PLANNING REPORT
PLANNING AND ZONING COMMISSION

SEPTEMBER 18, 2008

**5. Links at Ballantrae
08-026CP/Z**

**Rings Road West of Eiterman
Concept Plan
Rezoning/Preliminary Development Plan**

PROPOSED SITE PLAN

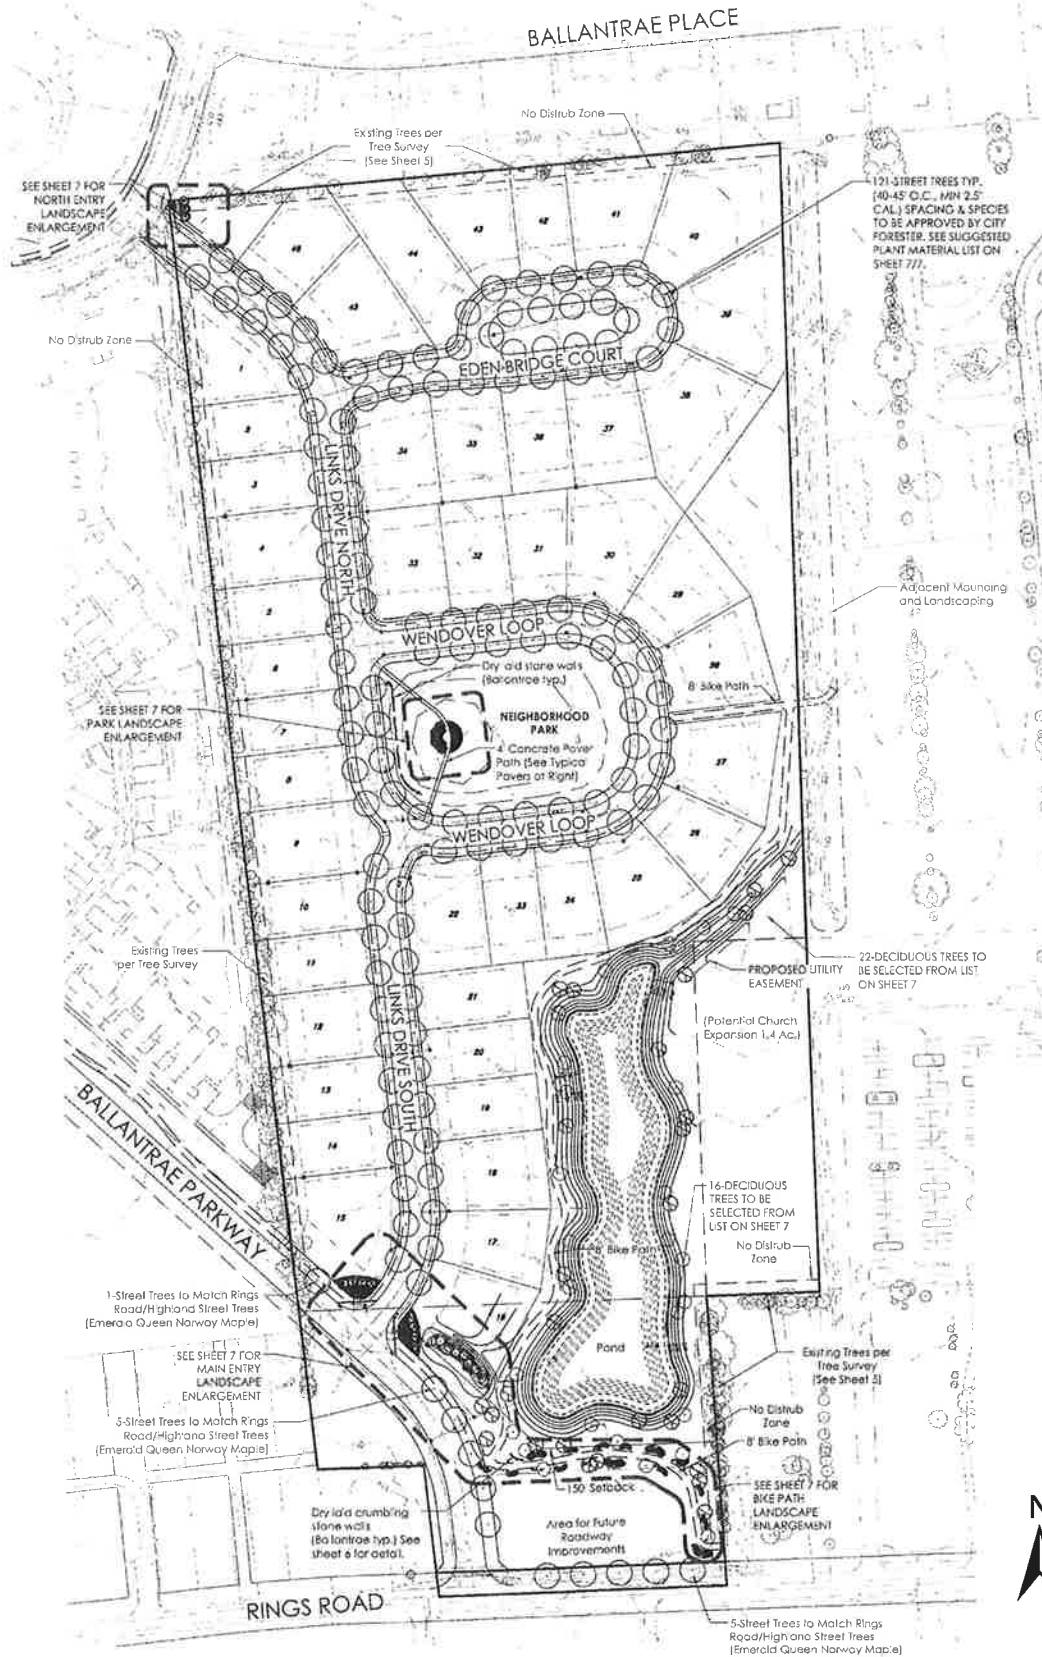
The plan generally lacks imagination and creativity in layout and design, resulting in a typical cookie-cutter design, contrary to what is called for in the Land Use Principles of the Community Plan. A more diverse street design and placement of open space is needed to adequately address the Plan. The excessively, long straight street segment from north to south is especially disruptive to the character contemplated by the Community Plan.

Washington Township Fire Department has reviewed the proposed plans and determined that the maneuverability of Eden Bridge Court can only be maintained by restricting parking on both sides of the street. While the restriction of parking is an option to ensure maneuverability of emergency vehicles, Planning, Engineering, and Fire are concerned that enforcement of this restriction will be difficult and is not practical for the residents.

Engineering and Fire have also expressed concern regarding the maneuverability within the Eden Bridge Court cul-de-sac, and recommends eliminating Reserve E in order to assist with emergency vehicle maneuverability and ensure a more practical parking arrangement for residents.

Planning and Engineering have expressed concern about the internal street connection provided between Ballantrae subdivision and Rings Road along Links Drive. The linear design of the roadway lends itself to increased cut-through traffic and between the public street system and the existing residential subdivision. Planning and Engineering recommend that modifications be made to the street layout to address this issue.

Code requires that front yard setbacks be a minimum of 35 feet where a bikepath runs through the front yard. Lots 28, 32, 45, and 46 are affected will need to be increased to meet the Code requirement.

Criteria not met: While the proposed site layout meets its apparent purpose of maximizing the number of units on the site, Planning and Engineering recommend that the site be redesigned to eliminate the long, straight street segments, the monotonous layout of the proposed lots along the western side of main access drive, the limited distribution of open space for western 15 lots, and the questionable development potential of several lots due to their size and shape. Planning recommends that the site layout, while technically meeting the standards outlined in the Code, be redesigned to encourage a design more in keeping with the Community Plan's Land Use Principles and future land use element.

Engineering has expressed significant concerns with the functionality of the proposed roadway network, and Planning requests alternative road layouts that would create a more attractive public realm and move a reasonable level of traffic. Alterations to the layout of Links Drive North and South throughout the site are recommended.

Land Use Principles not met: As proposed, the plan provides only single-family residential lots and associated open space. No connection to the existing development within the Village of Amlin has been provided. Planning is also concerned that the proposed lots located along the western boundary of the site may be located too closely to the Woodlands at Ballantrae condominiums. Locating more of the lots along the eastern site boundary while leaving more open space on the west side of the development may alleviate some of the potential conflicts that may result from the closely-spaced condos and residential lots in the western portion of the development as the proposal currently shows. Reducing this potential conflict will help integrate the proposal into the surrounding area.

- 1) That Reserve E be removed in order to improve maneuverability for emergency vehicles.
- 2) That the site layout be altered to provide for increased buffering along the western boundary of the site between the existing Woodlands at Ballantrae development and the proposed site.

- 3) That the front yard setbacks for Lots 28, 32, 45, and 46 be increased to accommodate the proposed bikepath.
- 4) That the plans and text be revised to eliminate the church use from the site.

- 6) That minor revisions to the bikepath alignment be made in the area of the proposed retention pond, prior to application for the Final Development Plan, to the satisfaction of the City Engineer.

- 8) That the plan be revised to address concerns regarding the potential cut-through traffic on Links Drive.
- 9) That the text clarify the ownership and maintenance responsibilities for the Reserves.
